**Final Remedial Investigation Report
Volume I**

Pfohl Brothers Landfill

**Cheektowaga, New York
Site Number 9-15-043**

ERRATA TO DRAFT REMEDIAL INVESTIGATION REPORT
FOR PFOHL BROTHERS LANDFILL RI/FS

Table G-1

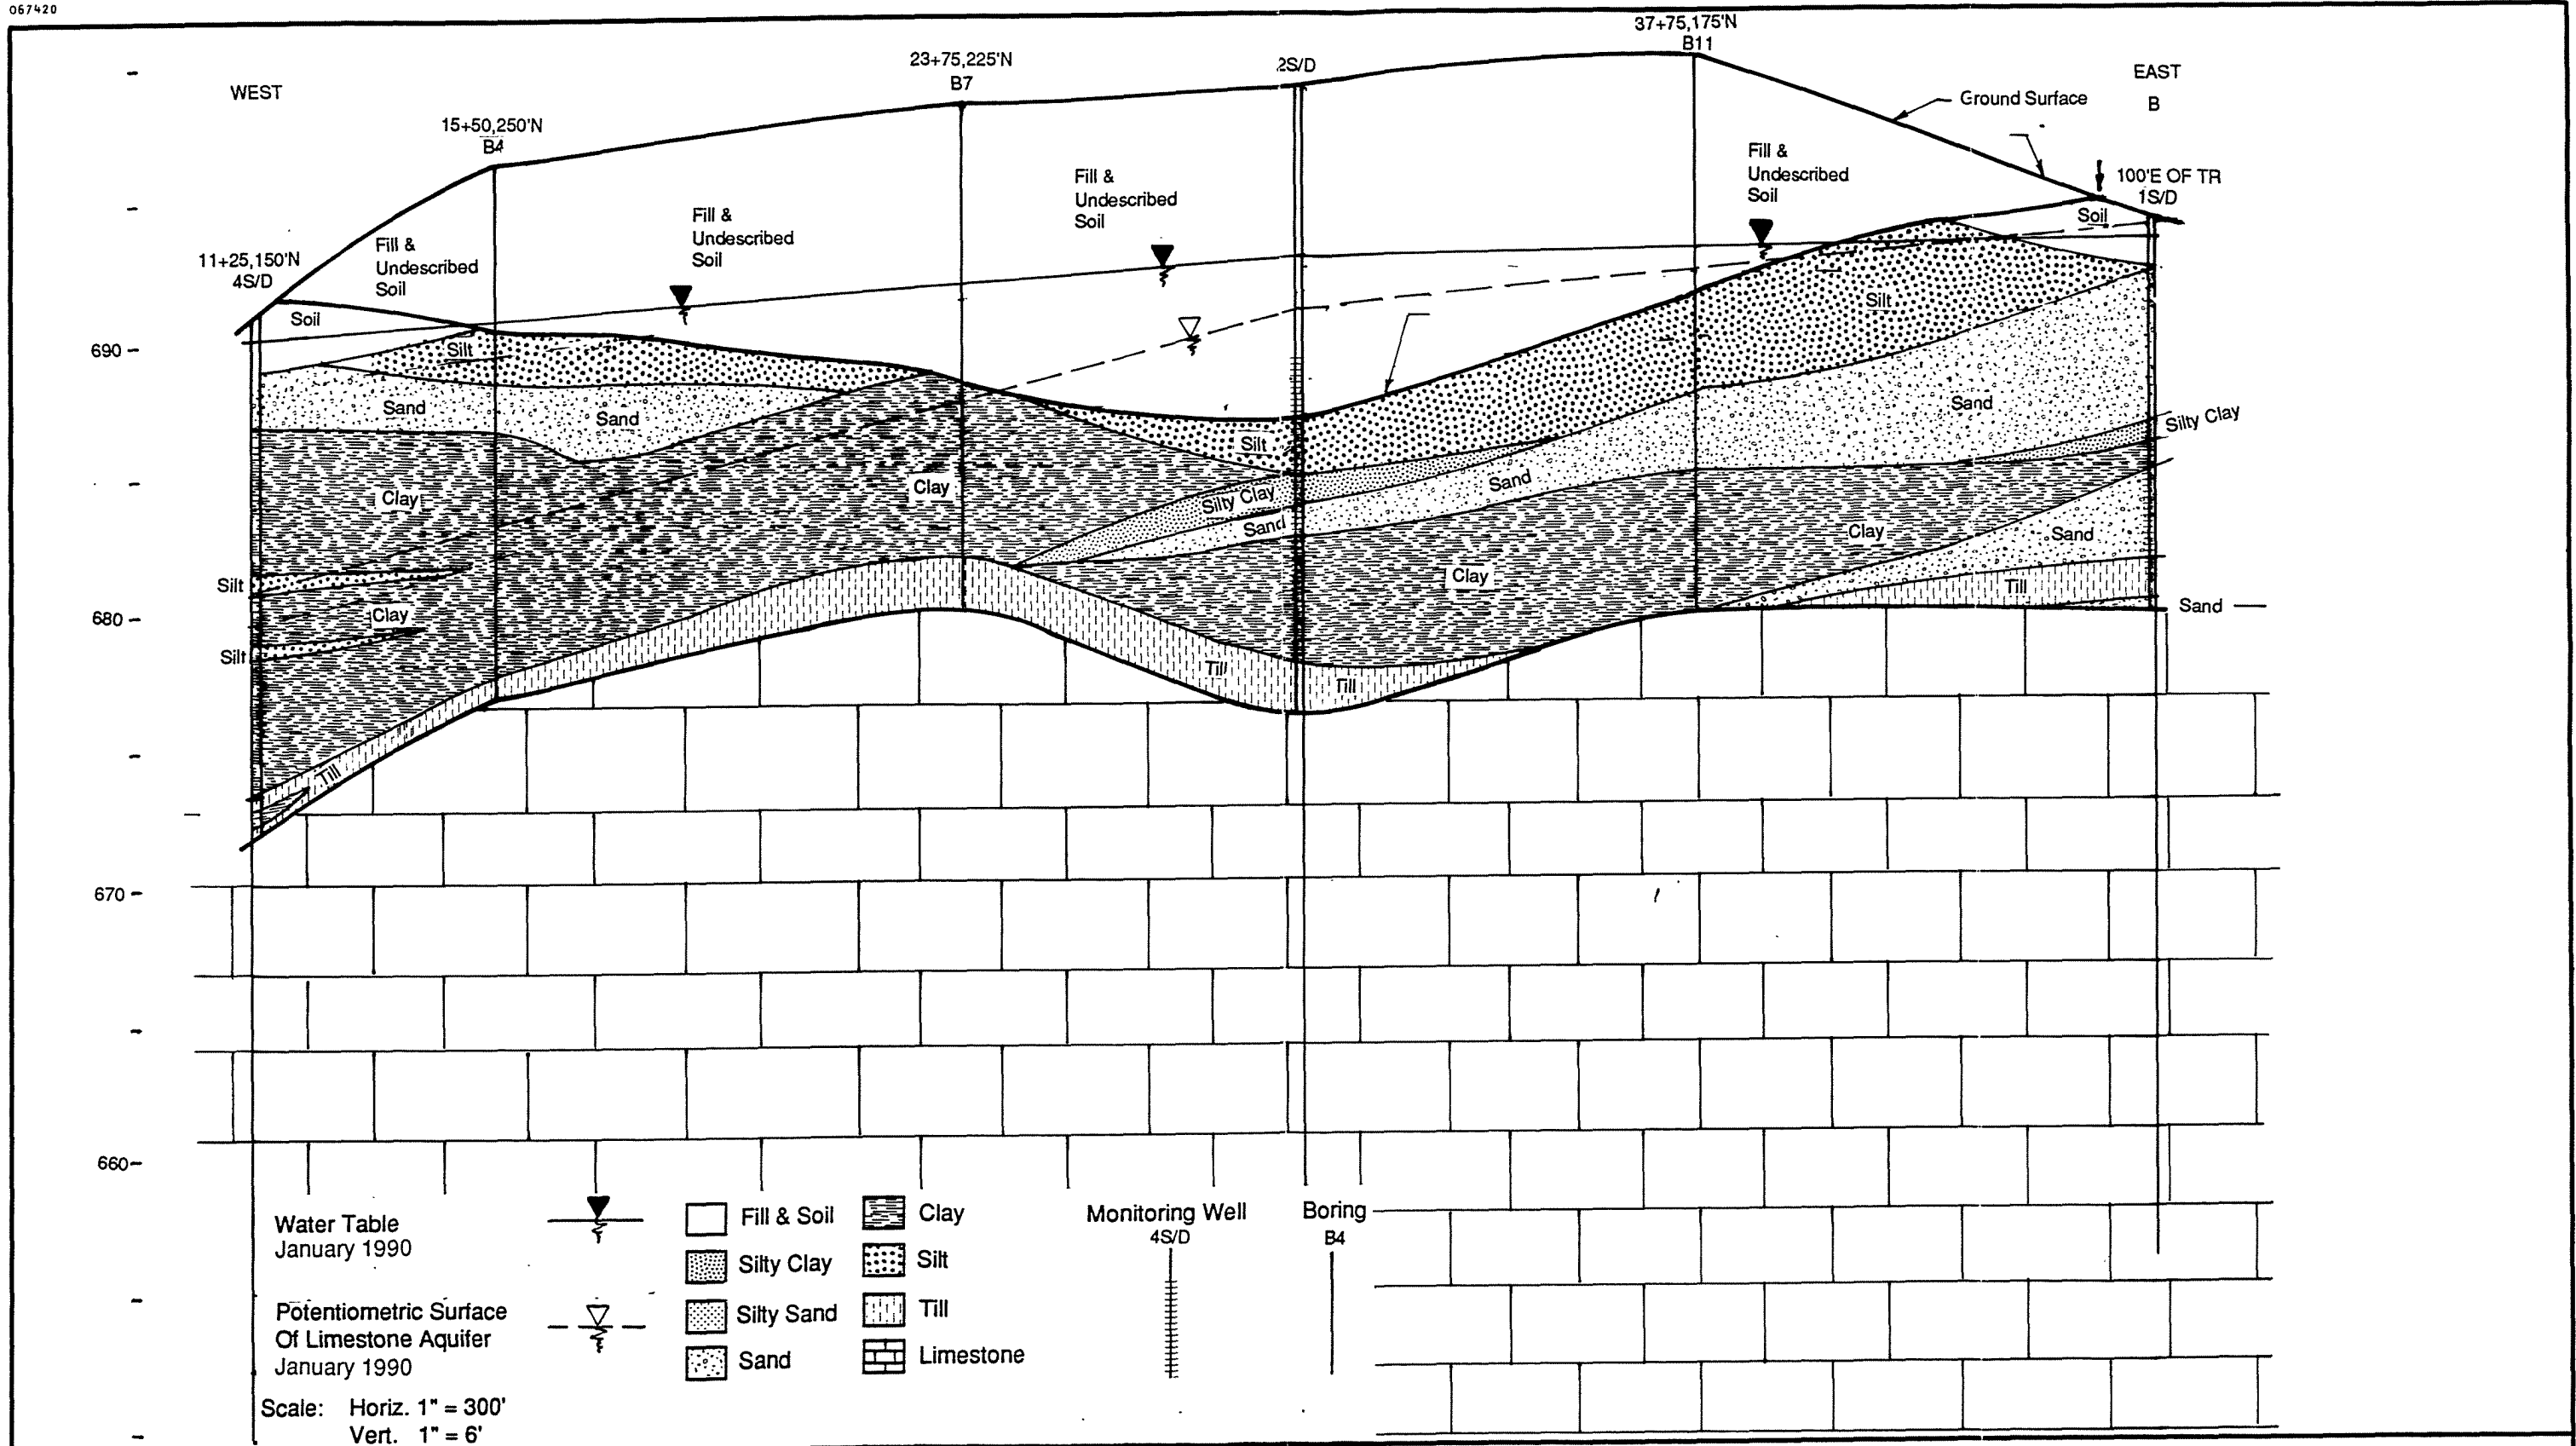
26. The mean hydraulic conductivity data presented in Appendix G of the Draft RI Report was multiplied by the saturated thickness of the bedrock aquifer which was based on the length of the well screen extending into the bedrock aquifer. Table G-1 (attached) replaces the original table entitled "Specific Capacity Test Results-Bedrock Wells", in Appendix G of the Draft RI Report. All references to hydraulic conductivity and specific capacity tests should be deleted from the text.

Figure 3-7

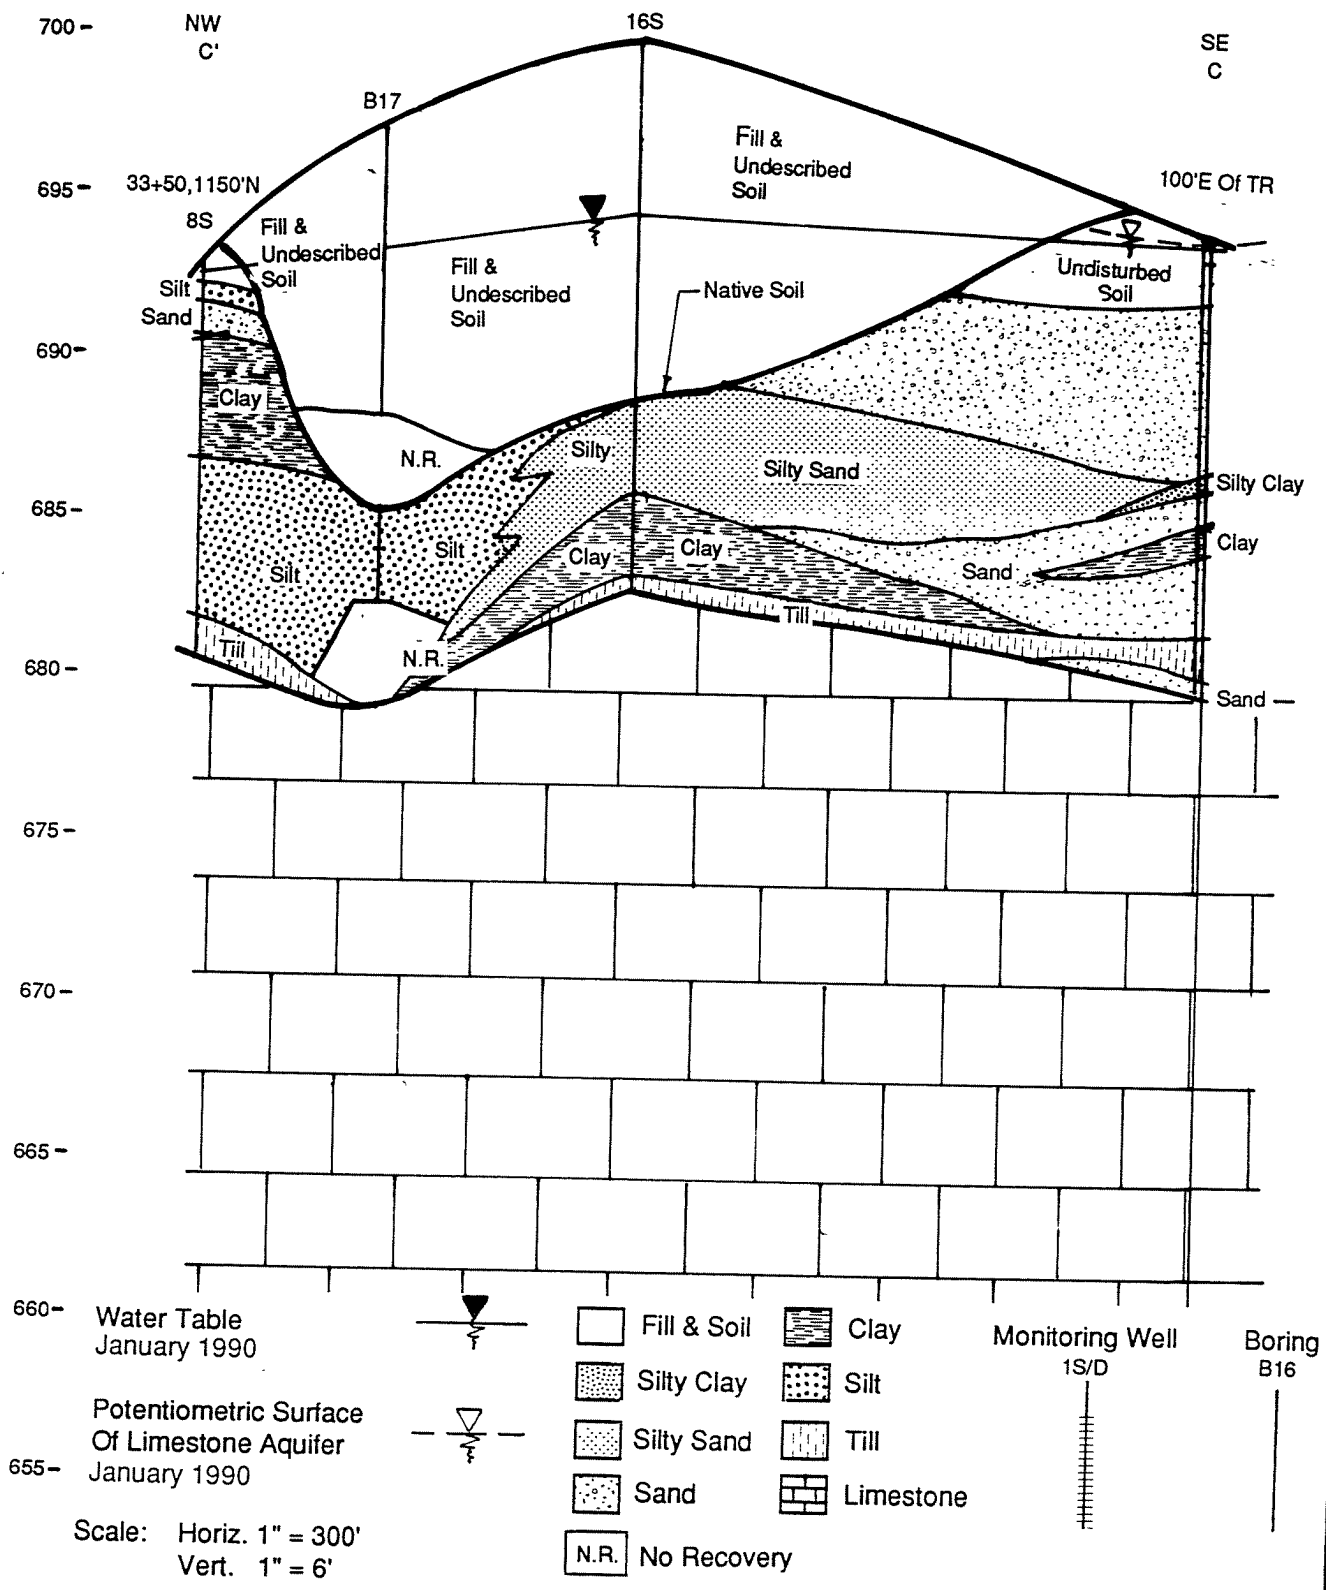
10. Figure 3-6 has been revised to show a clay unit at B7.
11. Boring location 34+50, 900'N on Figure 3-7, should be revised to read B-17. The interval of non-recovered material at B-17 between 10 and 12 feet bgs has been included on Figure 3-7.
